Appendix D

Common Boundary Rehabilitation Plan Landform

MTO / BCC Boundary Area

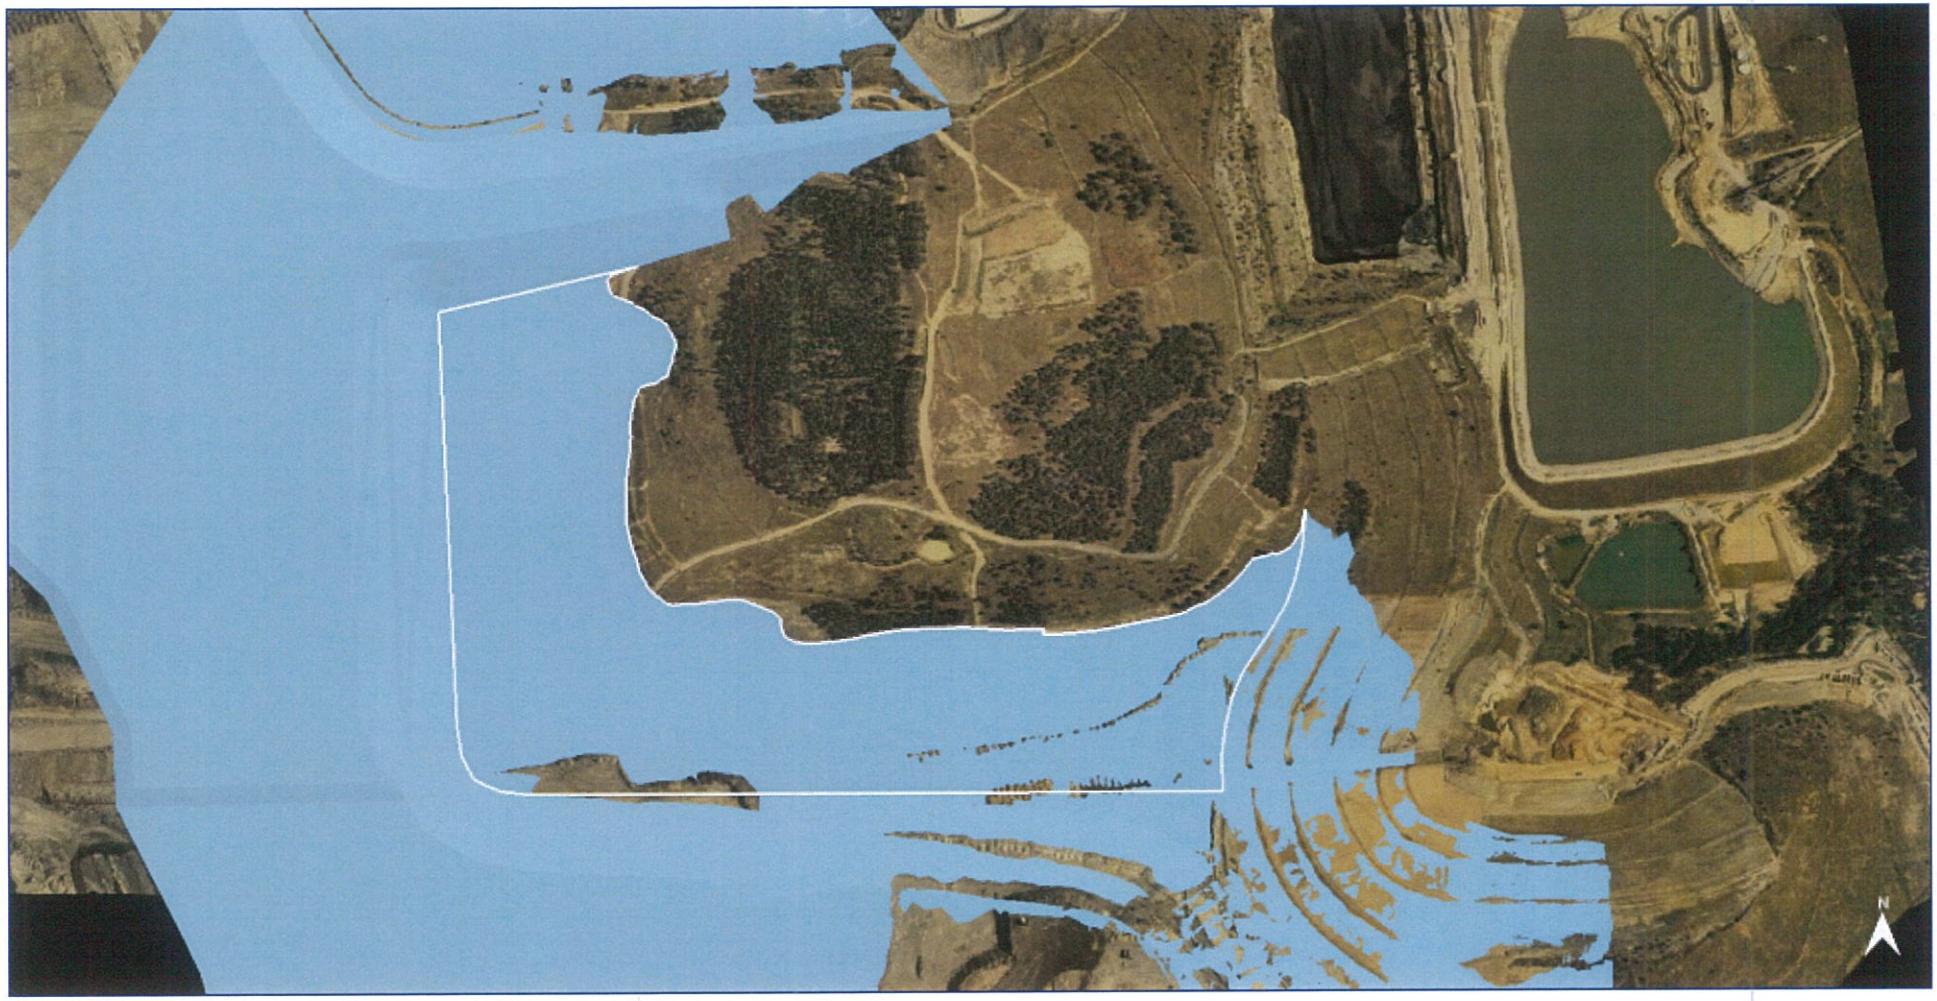
Boundary Area with Original Fill

Boundary Area with Proposed Fill

Section A

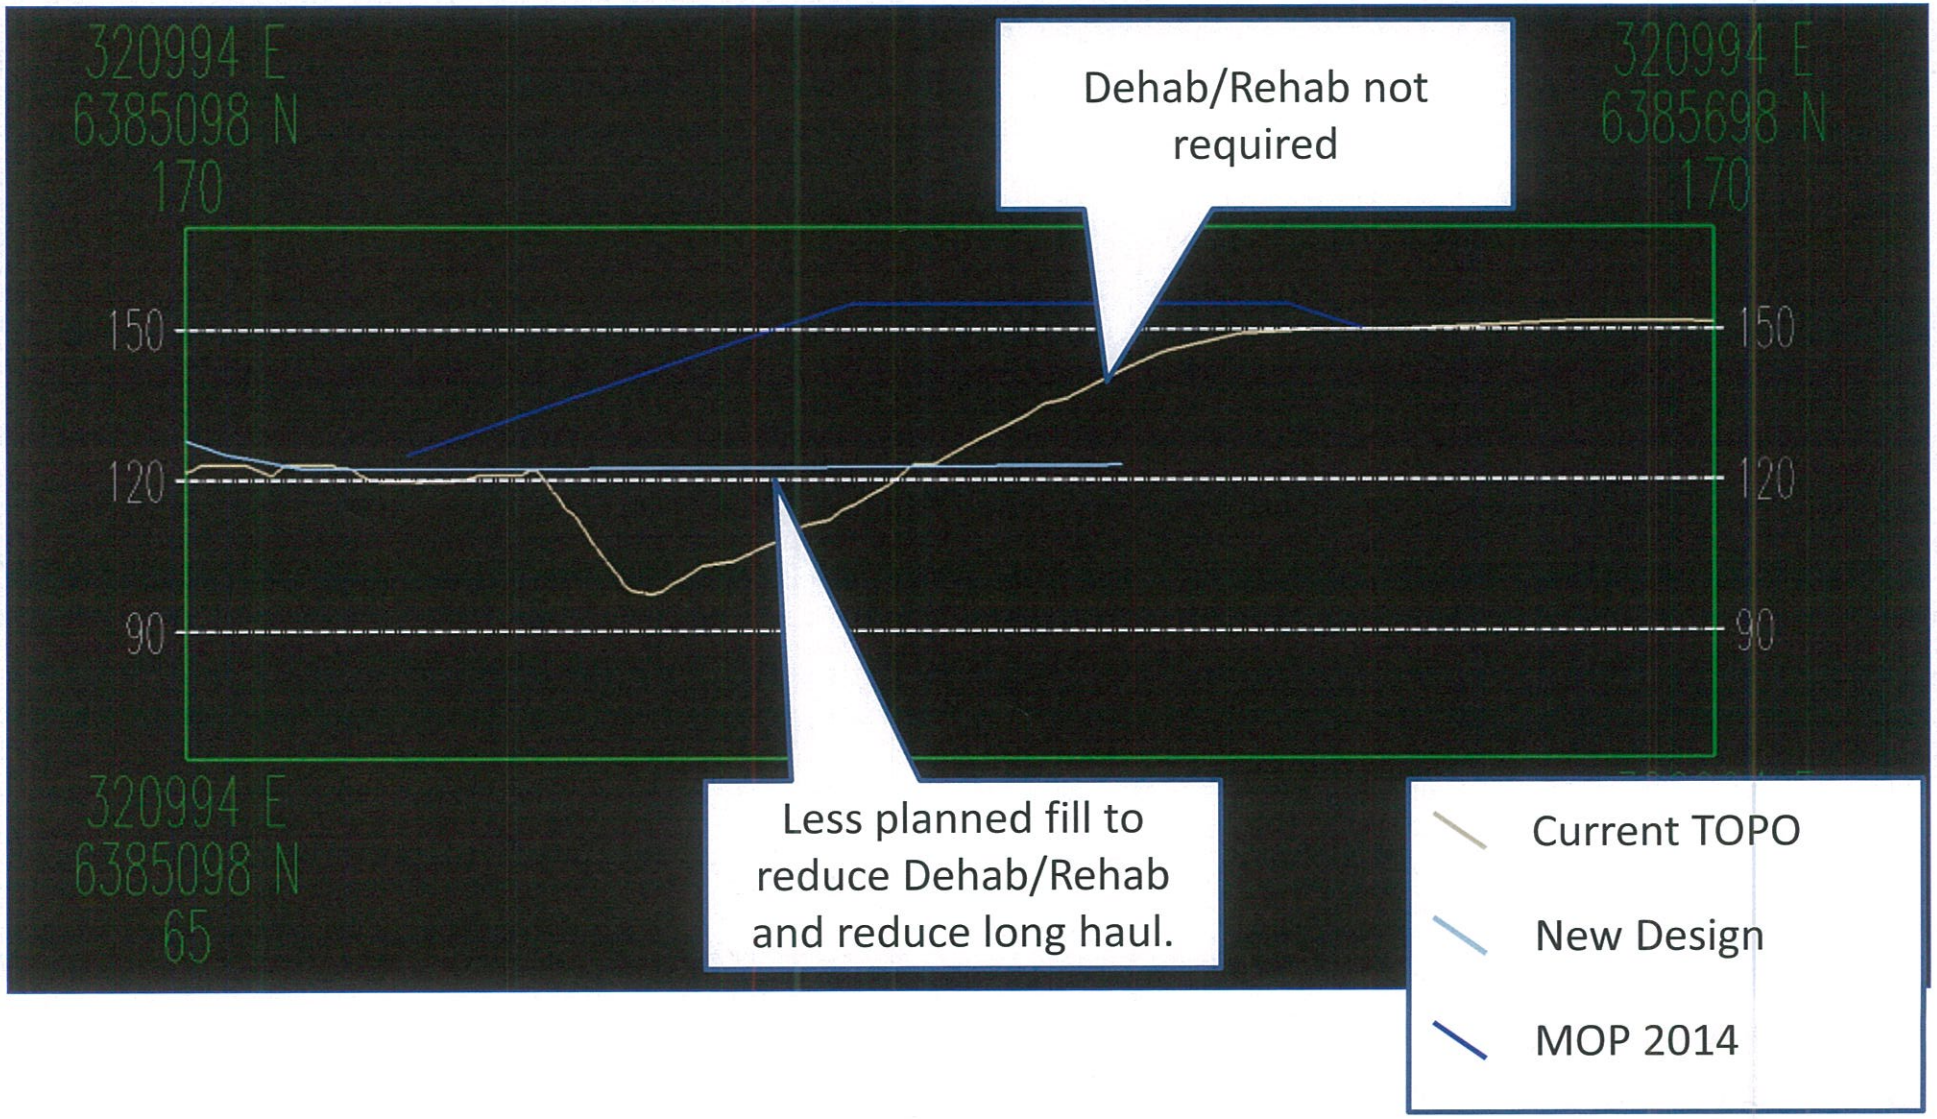
320994 E
6385098 N
170
320994 E
6385698 N
170
150
120
90
150
120
90
320994 E
6385098 N
65
Dehab/Rehab not required
Less planned fill to reduce Dehab/Rehab and reduce long haul.
Current TOPO
New Design
MOP 2014

Section B

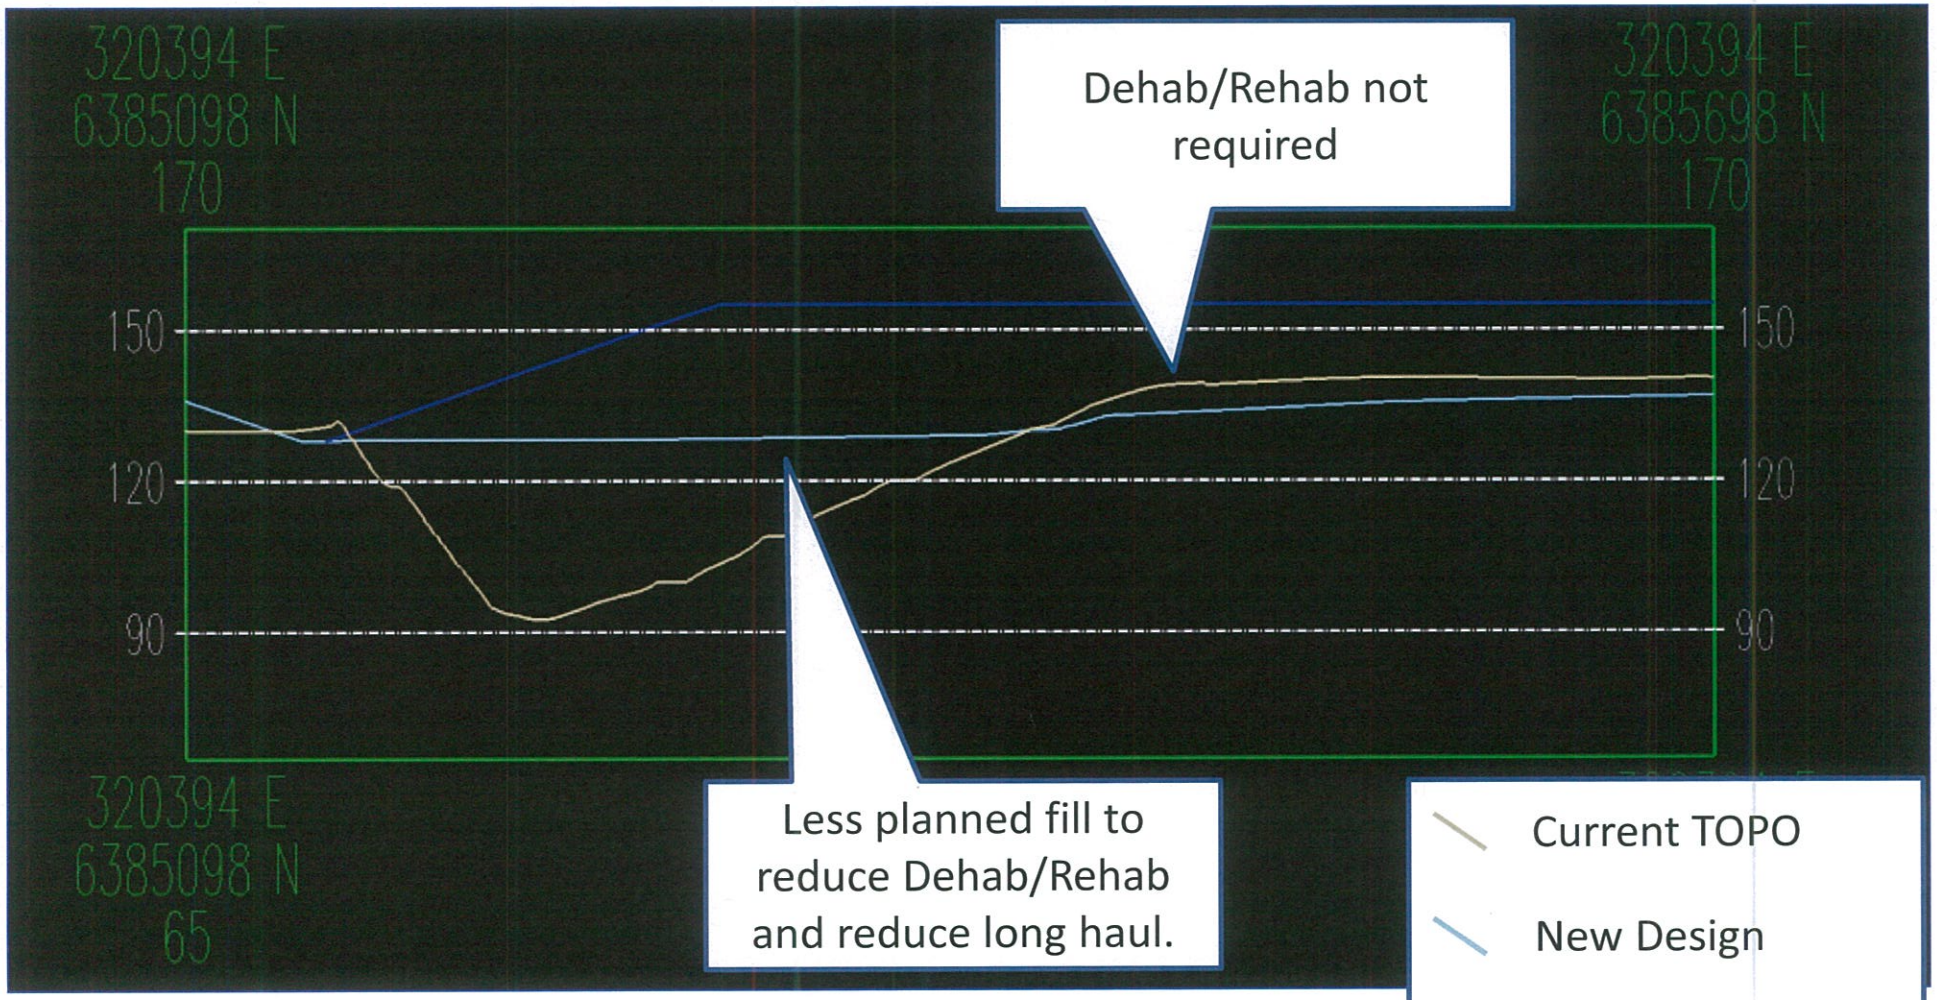
320394 E
6385098 N
170
320394 E
6385698 N
170
150
120
90
150
120
90
320394 E
6385098 N
65
Dehab/Rehab not required
Less planned fill to reduce Dehab/Rehab and reduce long haul.
Current TOPO
New Design
MOP 2014

Section C

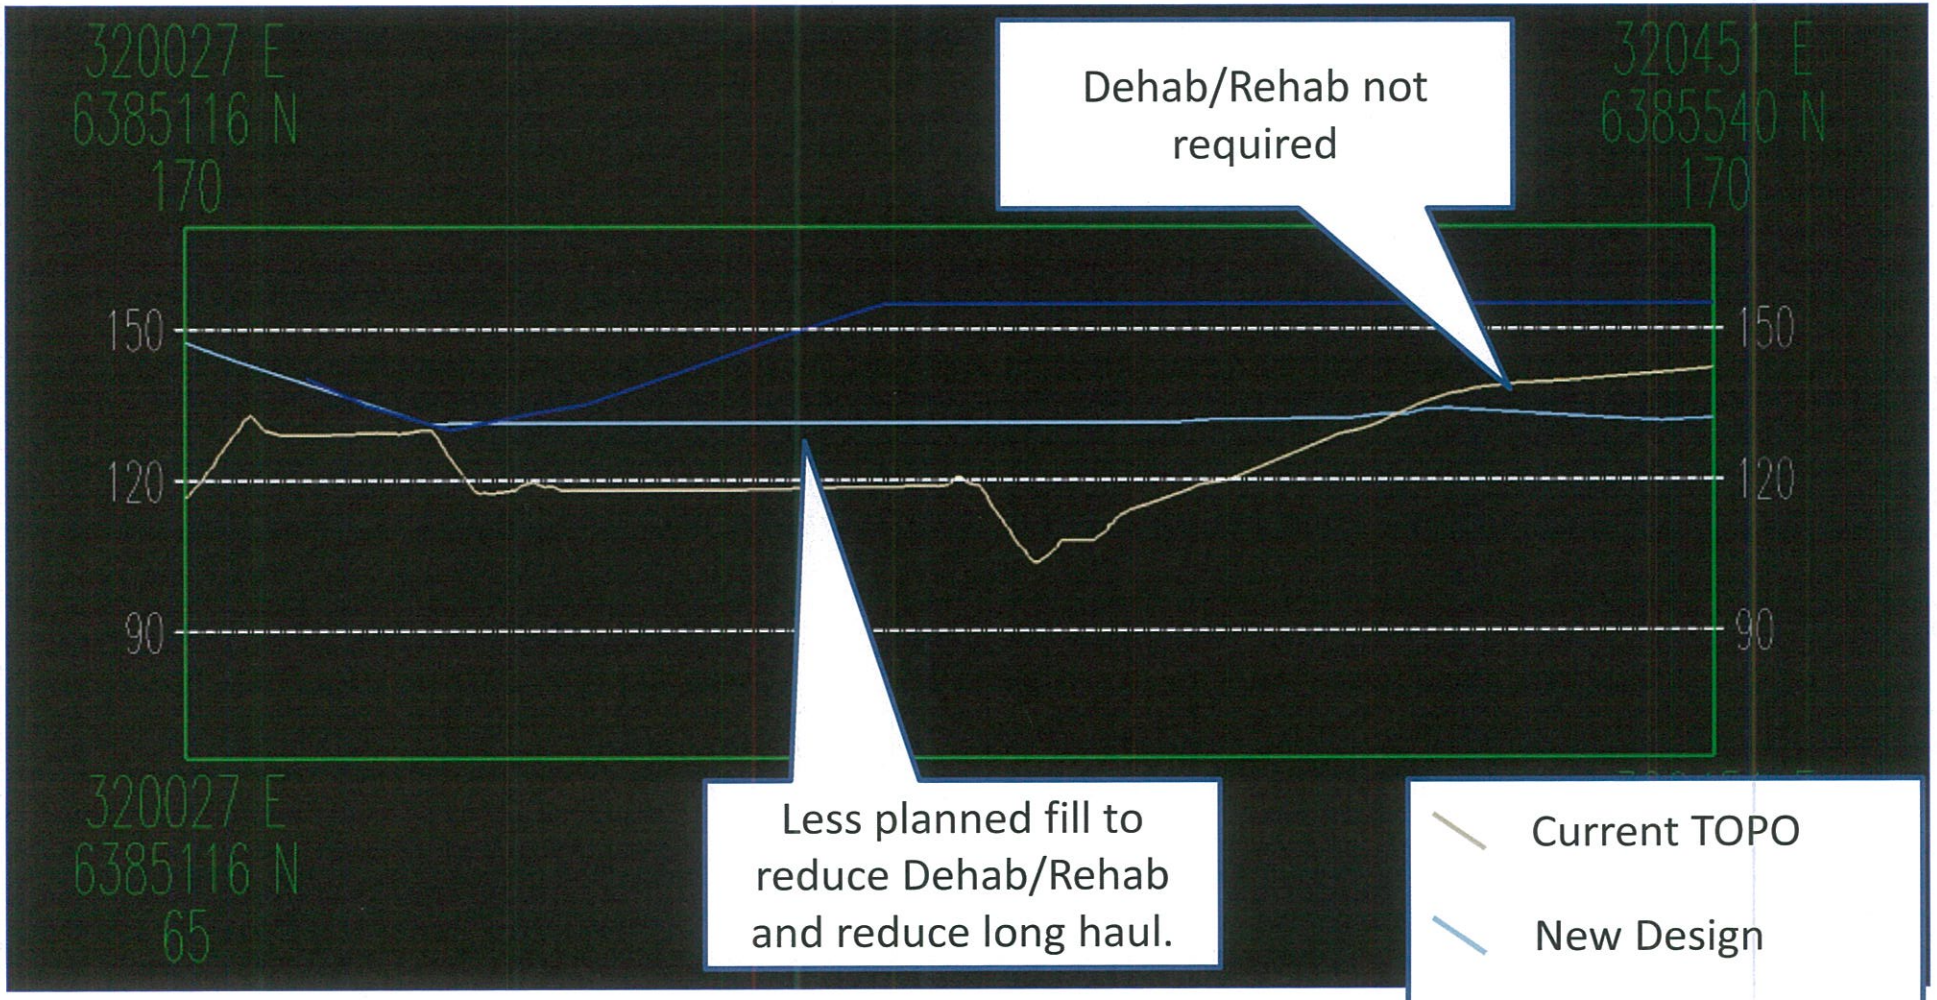
320027 E
6385116 N
170
320451 E
6385540 N
170
Dehab/Rehab not required
150
120
90
150
120
90
320027 E
6385116 N
65
Less planned fill to reduce Dehab/Rehab and reduce long haul.
Current TOPO
New Design
MOP 2014

Section D

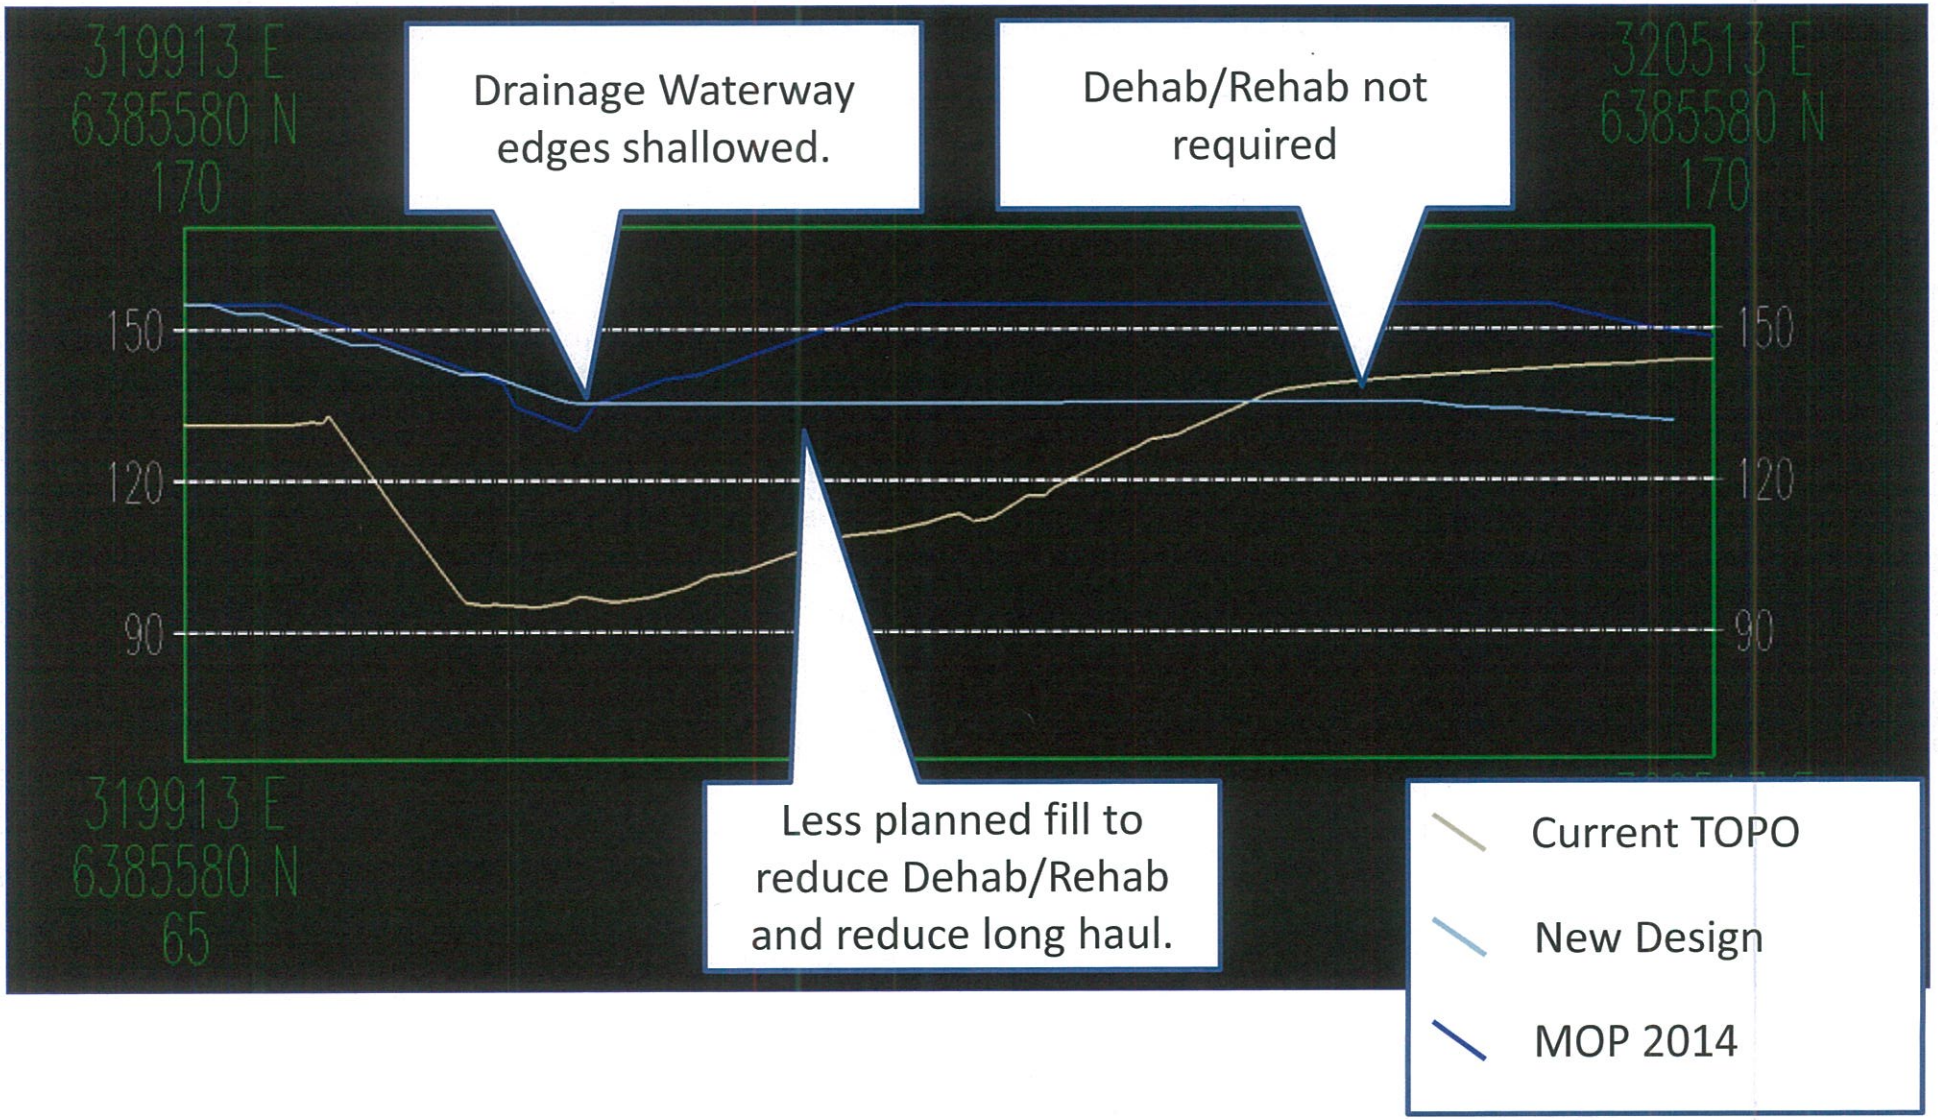
319913 E
6385580 N
170
Drainage Waterway edges shallowed.
Dehab/Rehab not required
320513 E
6385580 N
170
150
120
90
150
120
90
319913 E
6385580 N
65
Less planned fill to reduce Dehab/Rehab and reduce long haul.
Current TOPO
New Design
MOP 2014
